ADDENDUM NO. 02

July 25, 2025

Clark-Pleasant WCHS Phase 3
300 E Main St.
Whiteland, IN 46184

This Addendum consists of Pages ADD 2-1 through ADD 2-3 and attached Lancer Associates of Architects, Addendum No. 02, dated July 23, 2025, consisting of 8 pages, Specification Sections 08 41 15 and 28 23 00, and Addendum 2 Drawings: Drawing :208, 300, 500, 801, L101, L201, S002, S101G.2, S101GR, S101N.1, S101N.2, S102A, S102N.2, AD101G, A101GR, A141, A315, A316, A318, A731, A750, A760, PD100G.2, P100G.2, P101G.2, E702, E703.

SHEET 208

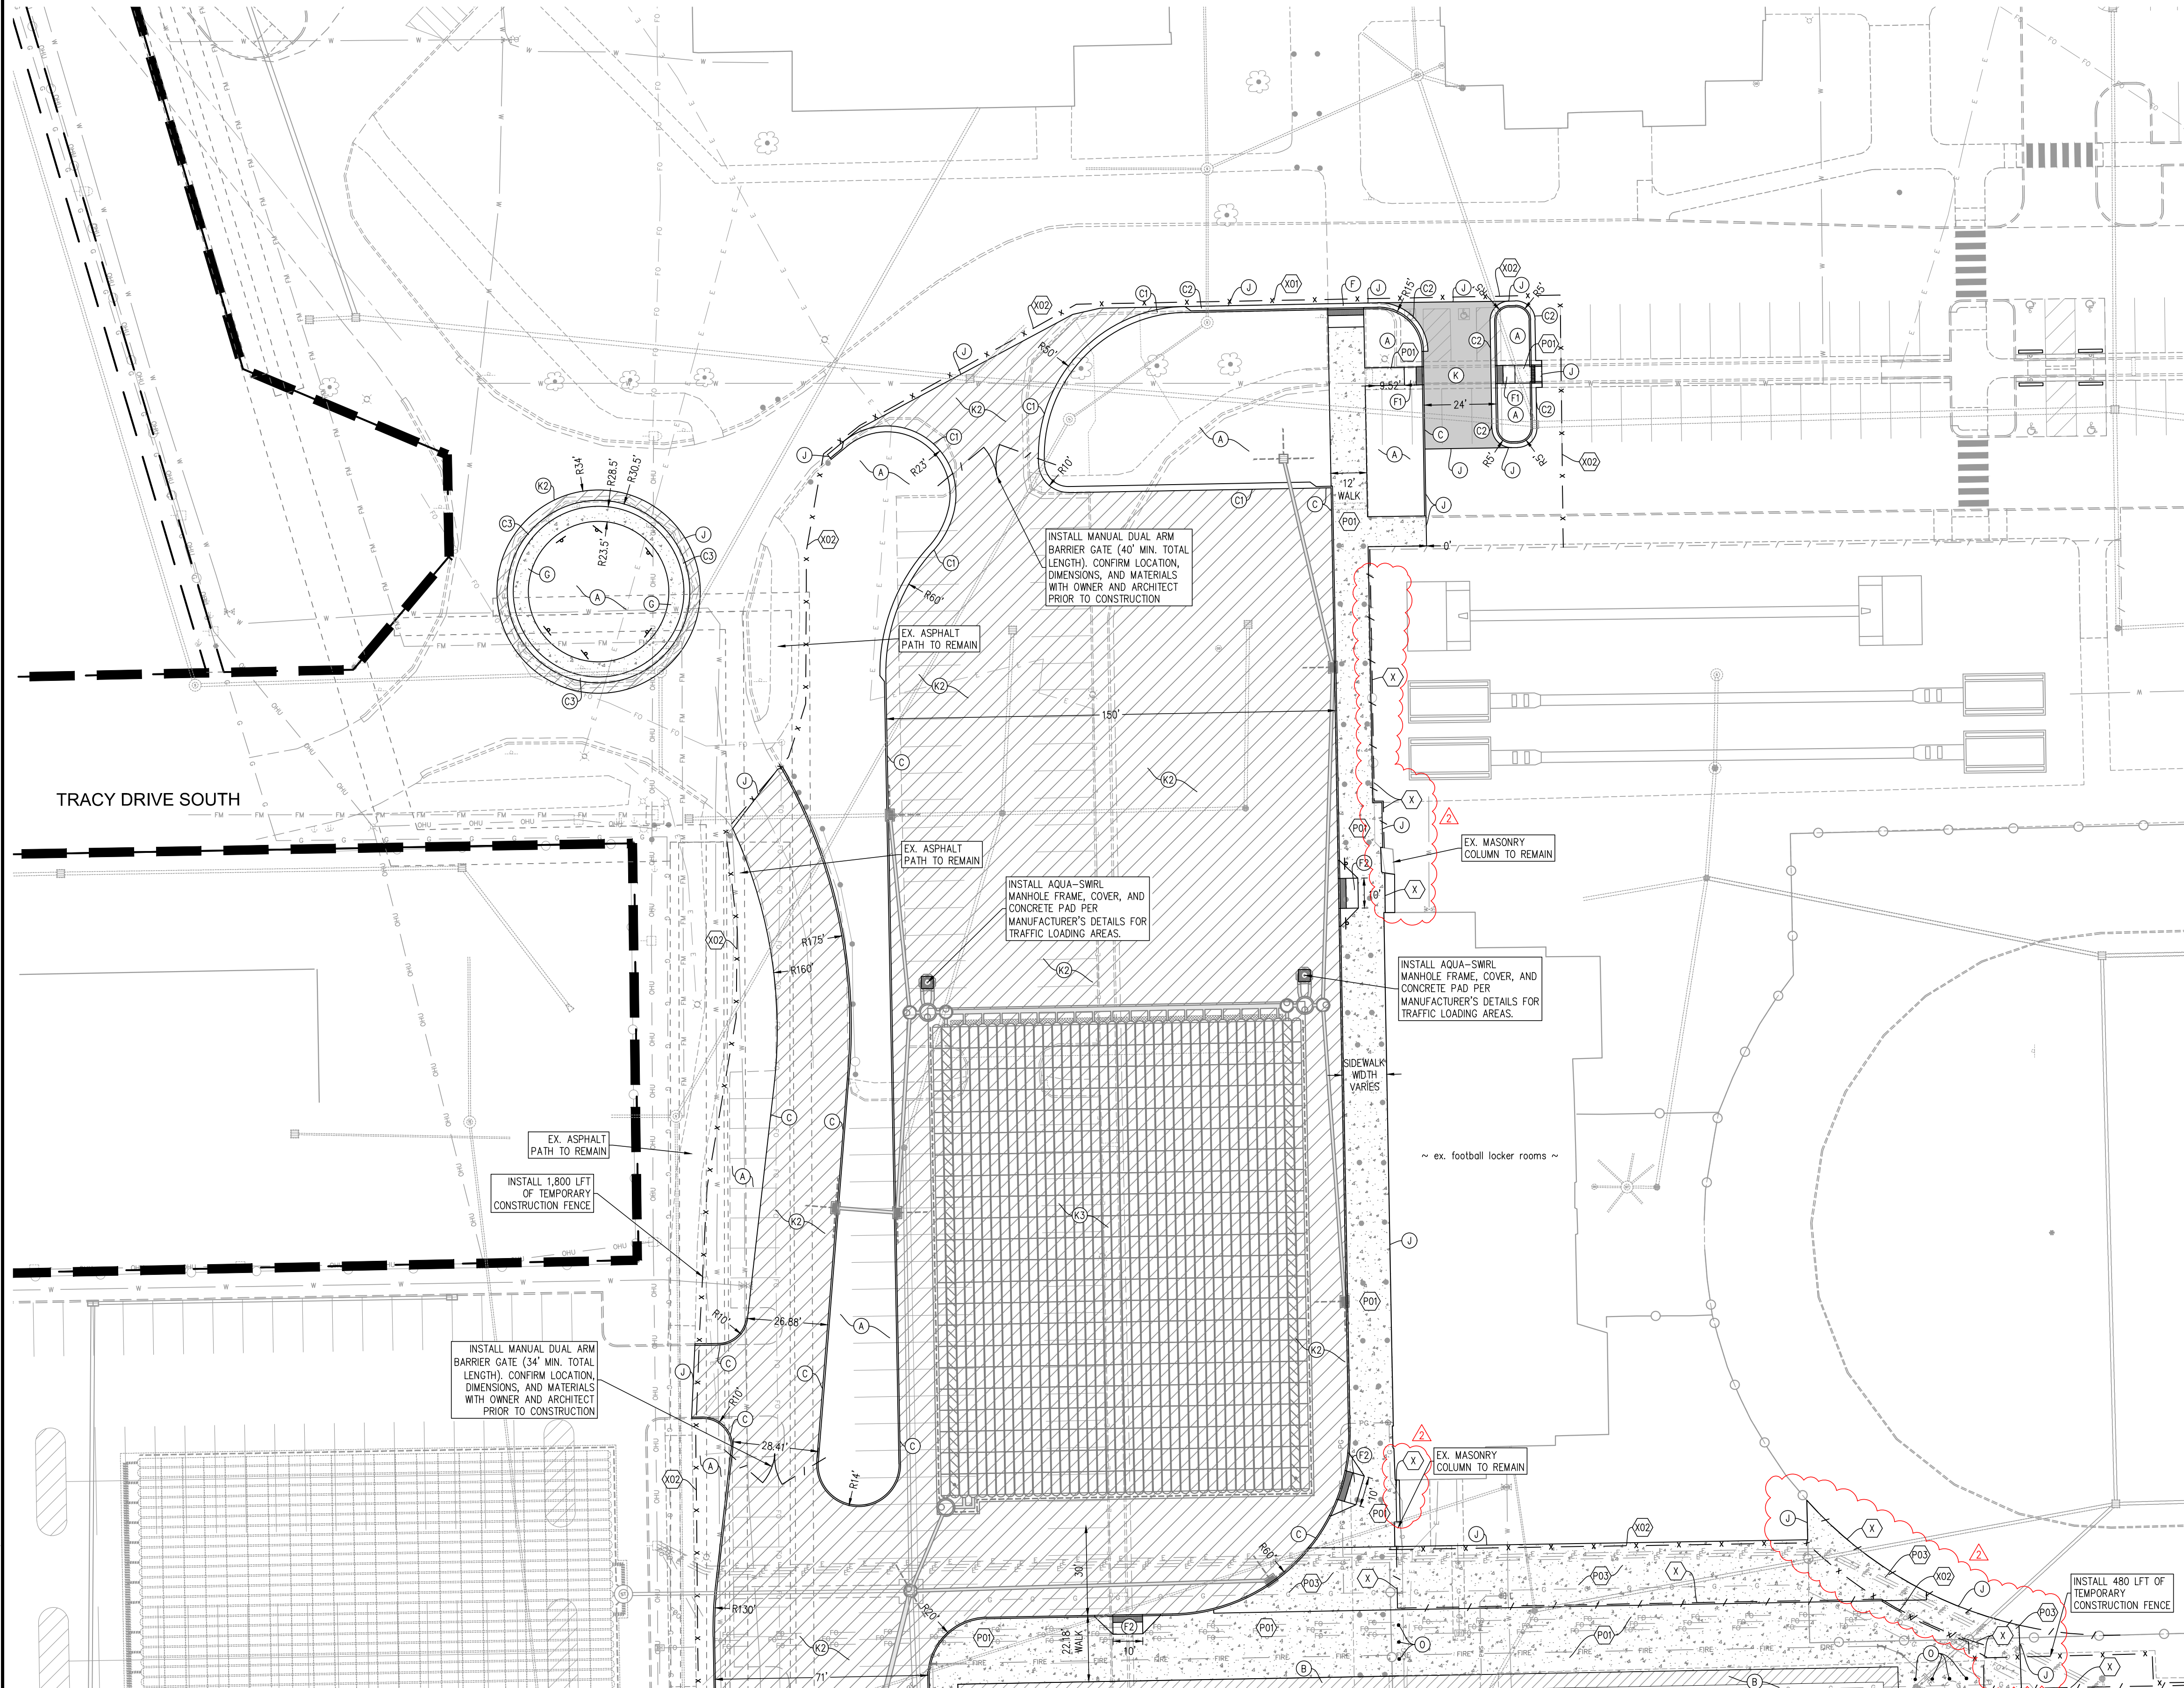
1. Drawing Demolition Plan (sheet 208):
 - a. Revised demolition limits on north side of building addition.
2. Drawing Site Dimension Plan (sheet 300):
 - a. Revised pavement and fence on north side of building addition.
3. Drawing Grading Plan (sheet 500):
 - a. Revised pavement grading on north side of building addition.
4. Drawing Erosion Control Plan (sheet 801):
 - a. Revised construction limits and silt fence on north side of building addition.

1 FOUNDATION PLAN - UNIT G.2
SCALE: 1/8" = 1'-0"

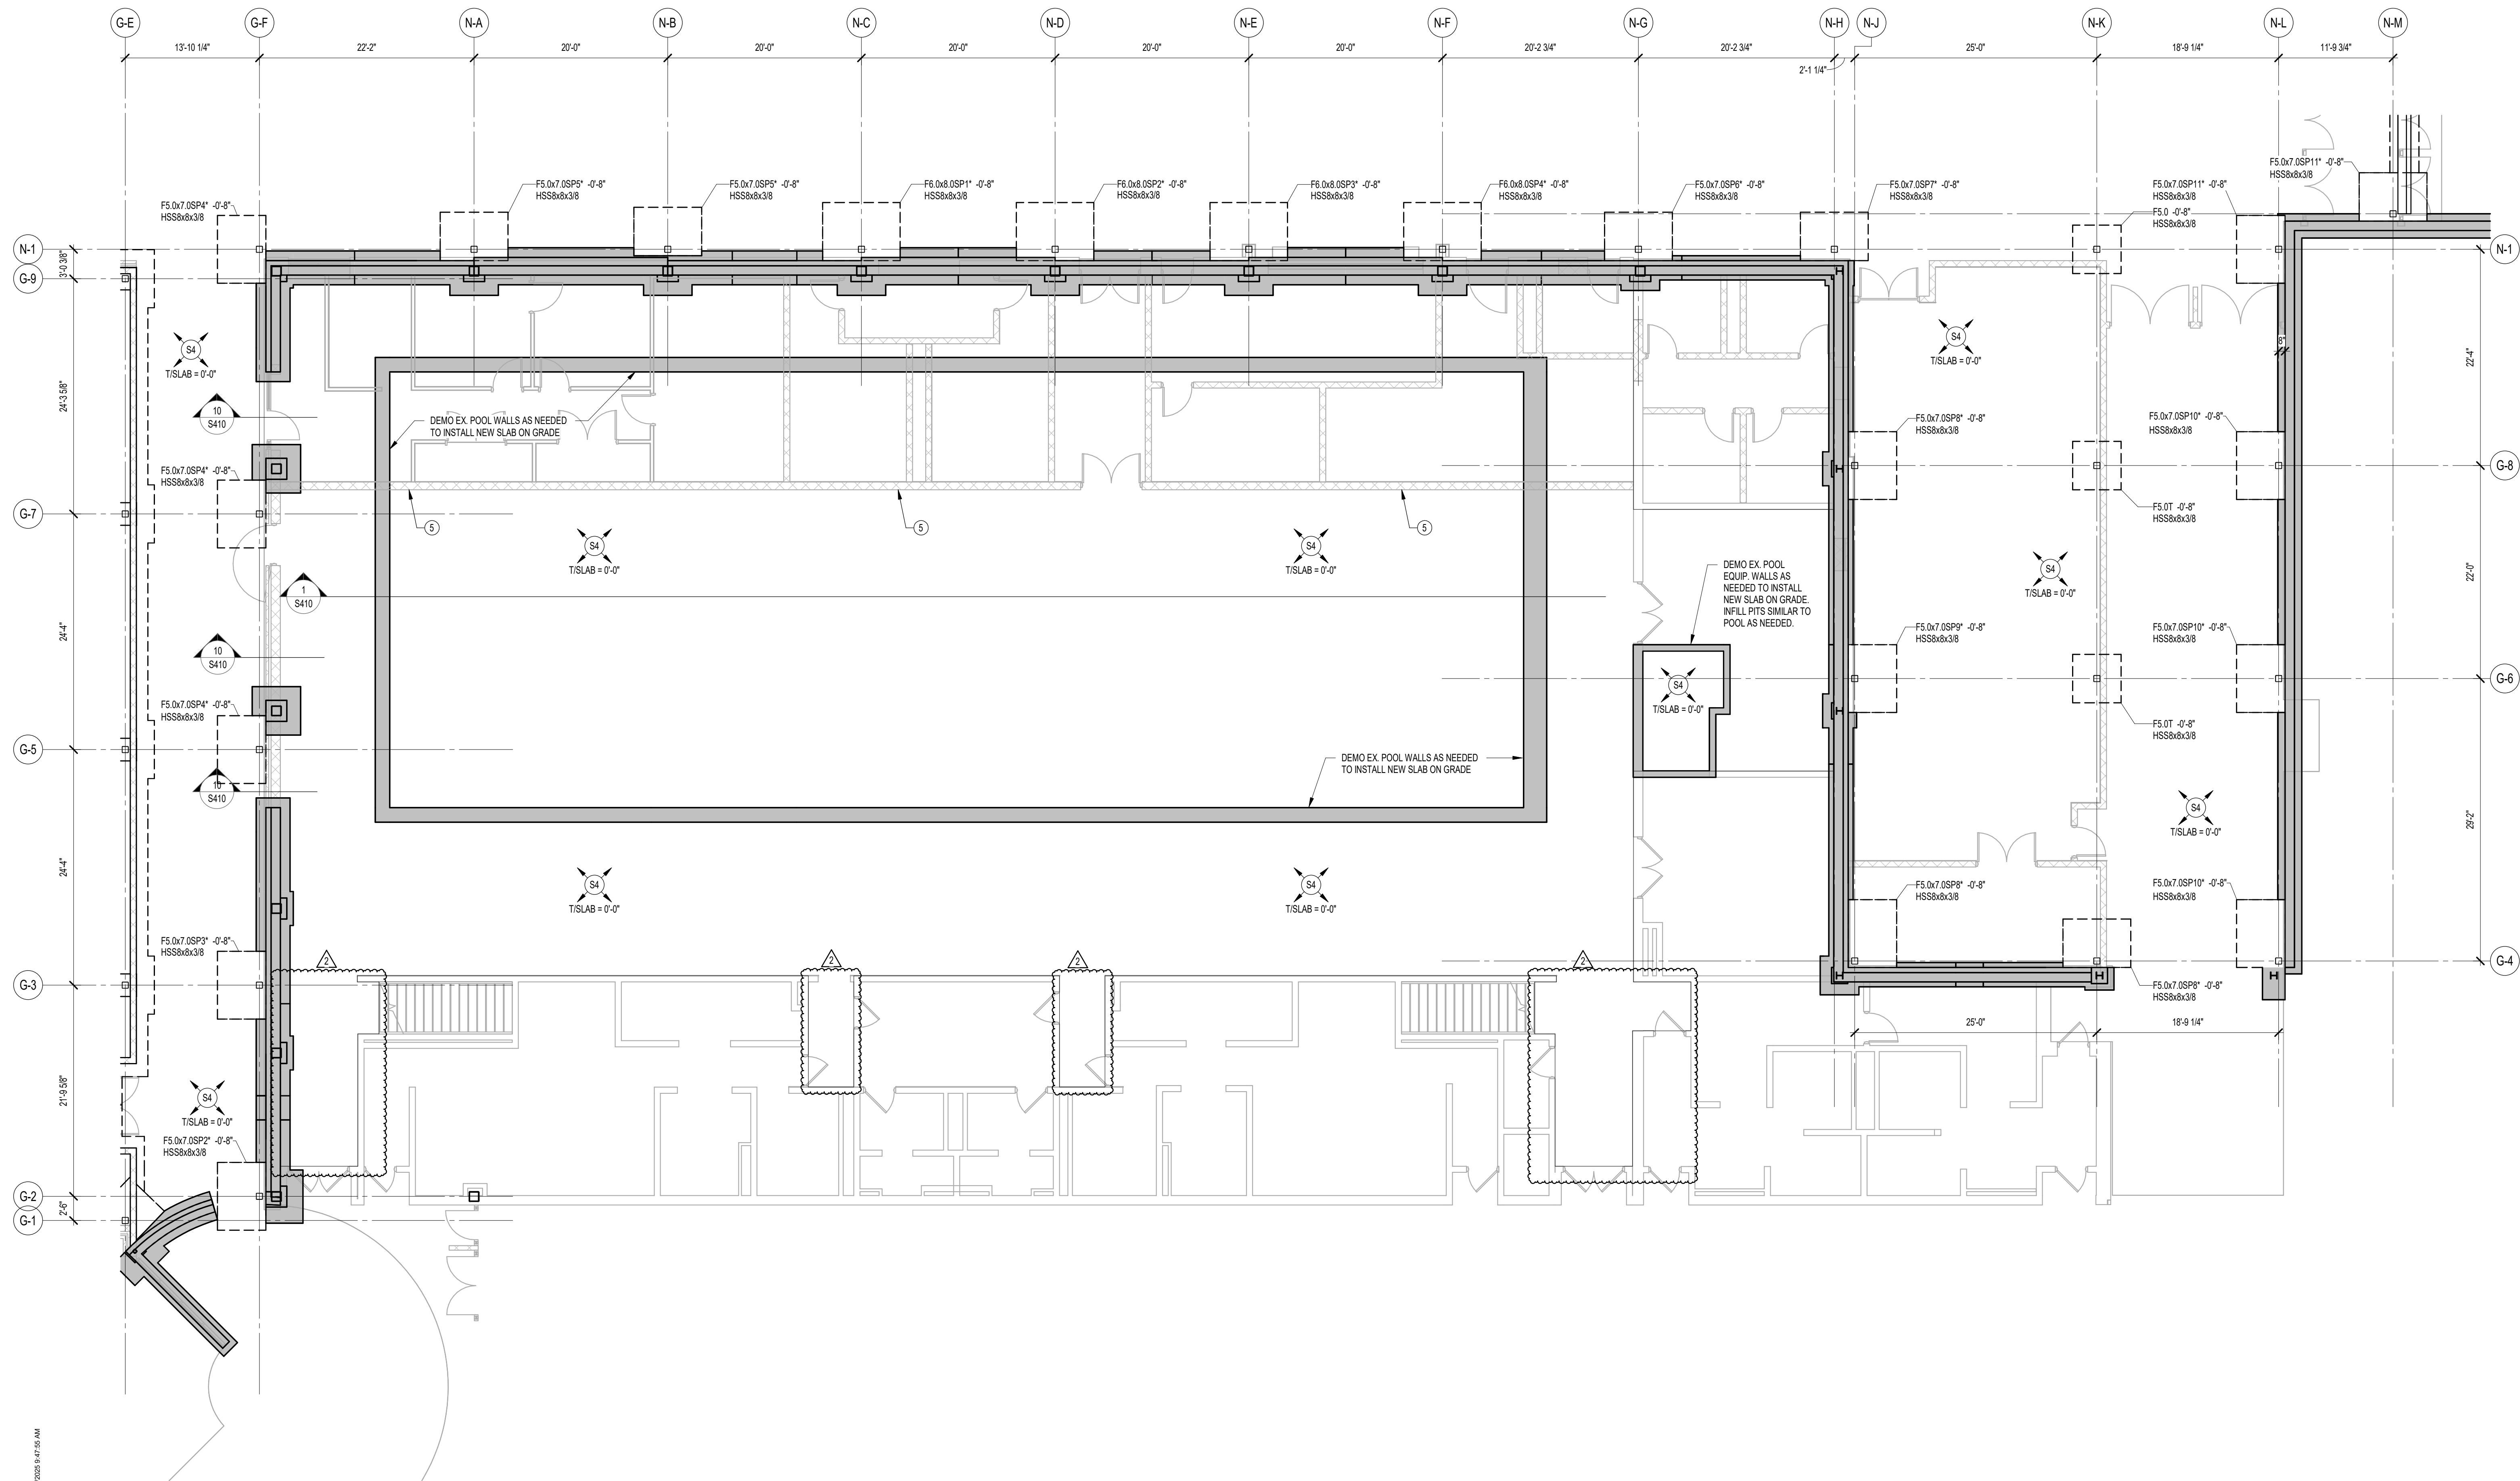
5. Drawing S101G.2 – FOUNDATION PLAN – UNIT G.2
 - a. Updated extents of new slab on grade to align with demo plans.
6. Drawing S102A – EX. LOW ROOF FRAMING PLAN – UNIT A

1 EX. LOW ROOF FRAMING PLAN - UNIT A

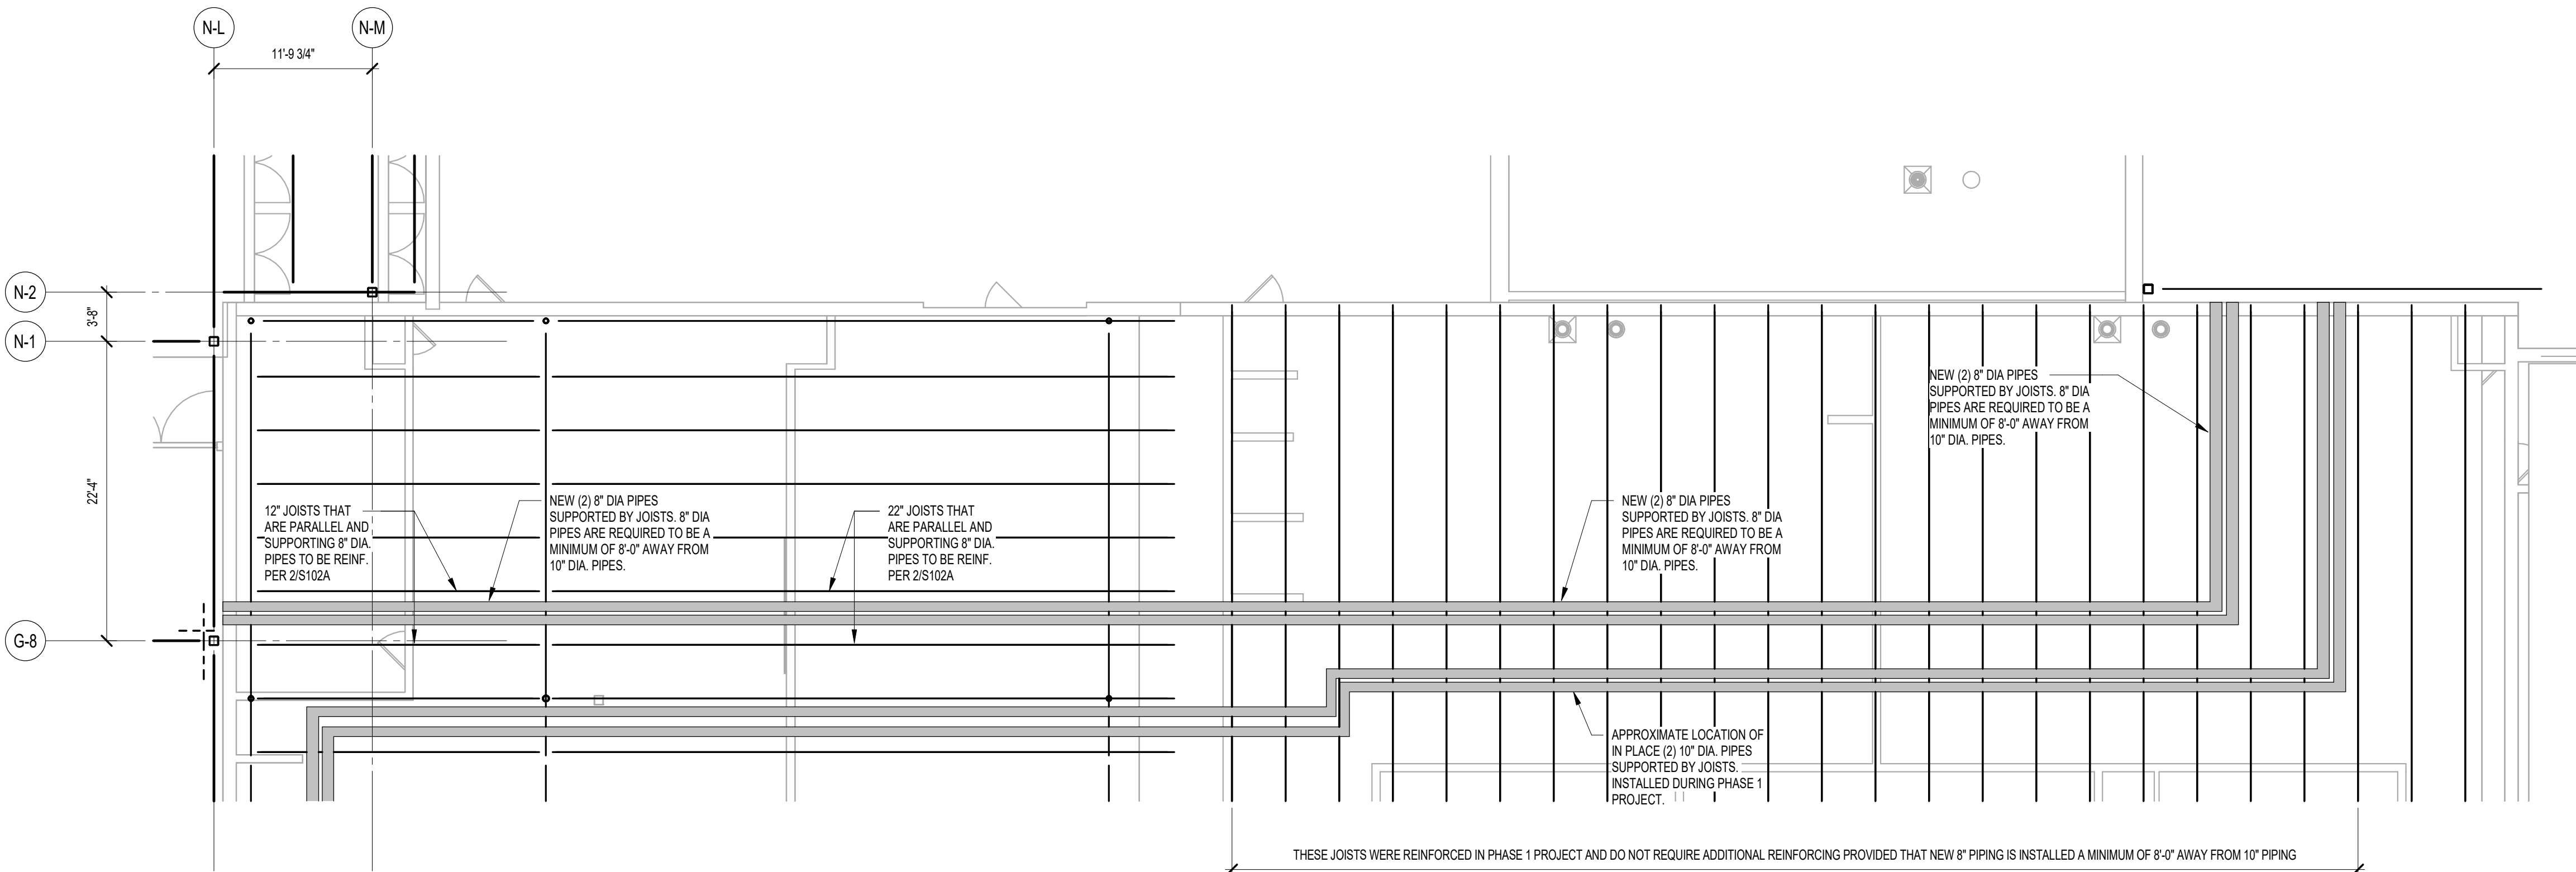
- a. New sheet showing added joist reinforcing details and requirements for new piping in existing building.
7. Drawing S102N.2 – SECOND FLOOR AND LOW ROOF FRAMING PLAN – UNIT N.2
